SUBJECT: Duke Energy Carolinas, LLC (Duke Energy)

Catawba Nuclear Station (CNS), Units 1 and 2 Docket Nos. 50-413 and 50-414 Renewed License Nos. NPF-35 and NPF-52

First Six-Month Status Report in Response to March 12, 2012 Commission Order Modifying Licenses With Regard to Requirements for Mitigation Strategies for Beyond-Design-basis External Events (Order Number EA-12-049)

FIRST SIX MONTH STATUS REPORT (ORDER EA-12-049)

PRIMARY INJECTION

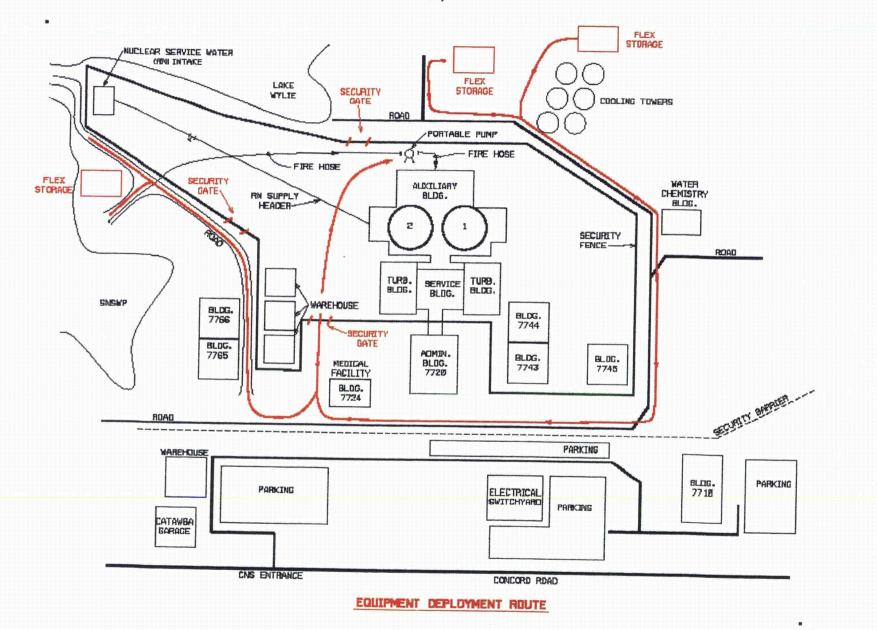
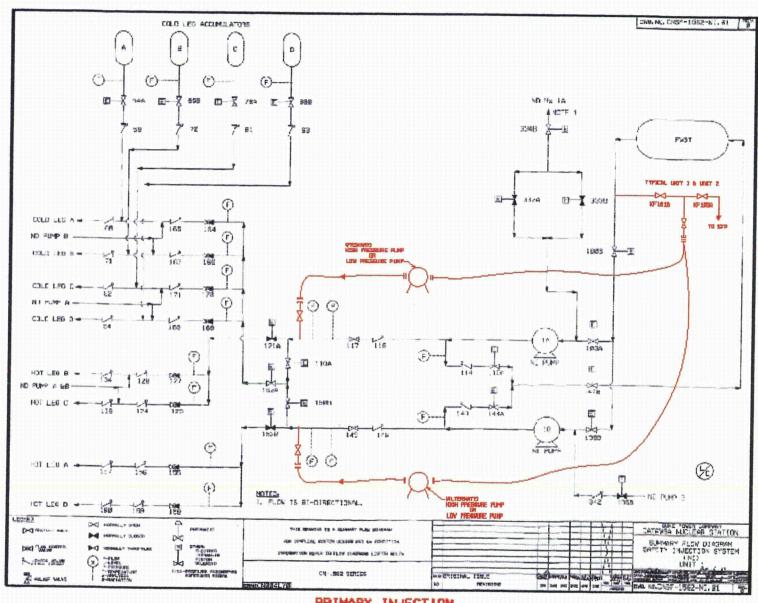
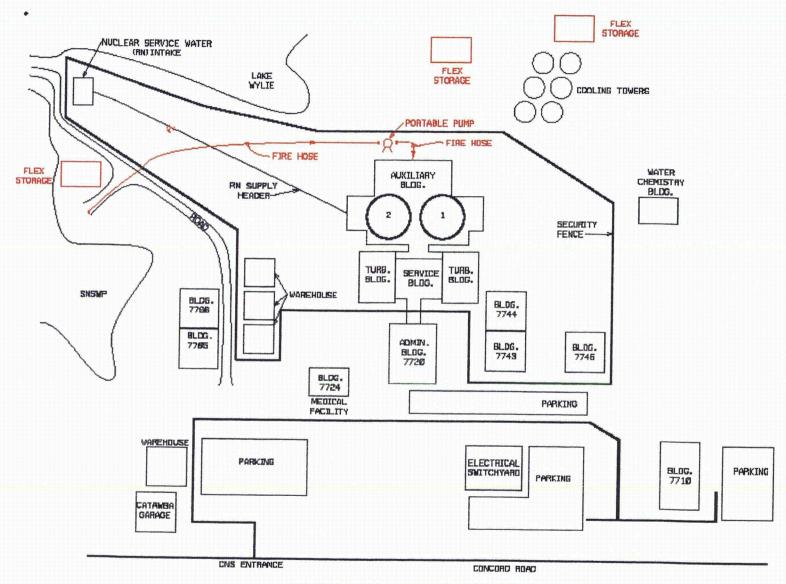
3) Change: The borated water suction connections for the high pressure and low pressure pumps have changed. A new Refueling Water Storage Tank (FWST) piping connection will be added between valves KF-101B and 103A on Unit 1 and Unit 2 to serve as the primary and alternate borated water suction source for the high pressure and low pressure pumps. The single primary or alternate connection point will tie into a gated wye type adapter that will be used to supply the pumps which inject into each unit.

<u>Justification</u>: It has been determined that the pump selected for use as the portable Steam Generator make up pump can also be used as the low pressure borated water Reactor Coolant System (RCS) make up pump since both of these strategies will not be performed at the same time. The physical size, type of driver (diesel engine), and deployment location requirements dictate that this pump will need to be stored/staged outside of the Auxiliary building. As such, a more viable borated water pump suction connection had to be found for the low pressure pump. This new connection was also determined to be capable of supplying the high pressure pump, thus eliminating the previously identified borated water pump suction connections in the A and B Safety Injection pump rooms on each unit and the need to purchase additional low pressure injection pumps.

<u>Documentation</u>: Open Item #36, Open Item #37, Open Item #75, Attachment 1 (Revised sketches)

PORTABLE PLMP SUPPLY TO CONTAINMENT SPRAY

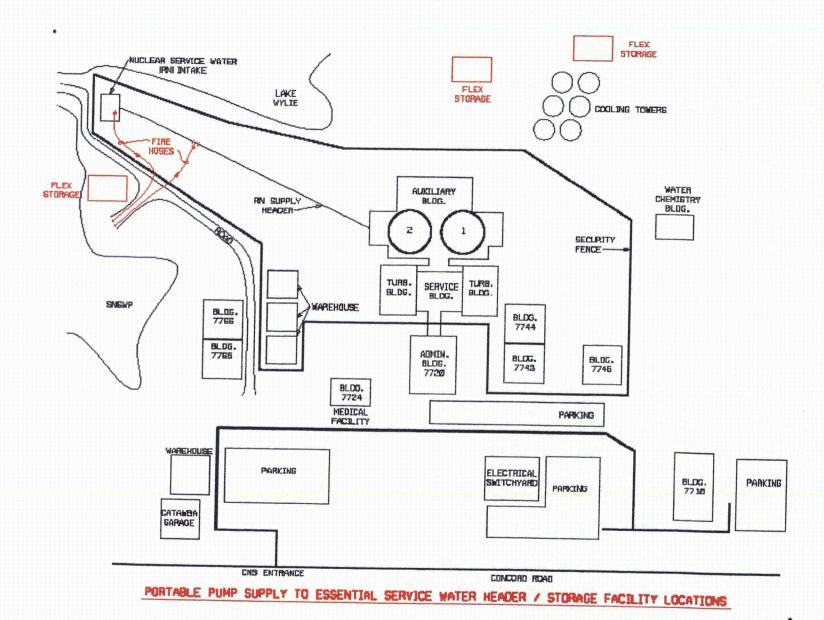
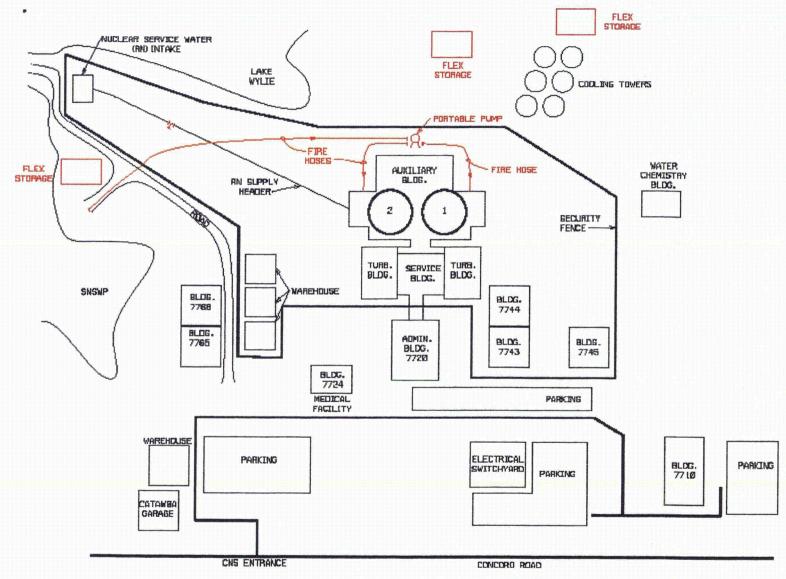
5) <u>Change</u>: Three FLEX storage buildings will be utilized with one building located near the SNSWP and the other two buildings located in the cooling tower yard area.

<u>Justification</u>: Relocation of two of the three FLEX storage buildings provides better access, less construction issues, and improved flood protection. The three buildings will still meet NEI 12-06 requirements for all hazards applicable to the site.

Documentation: Open Item #27, Attachment 1 (Revised sketches)
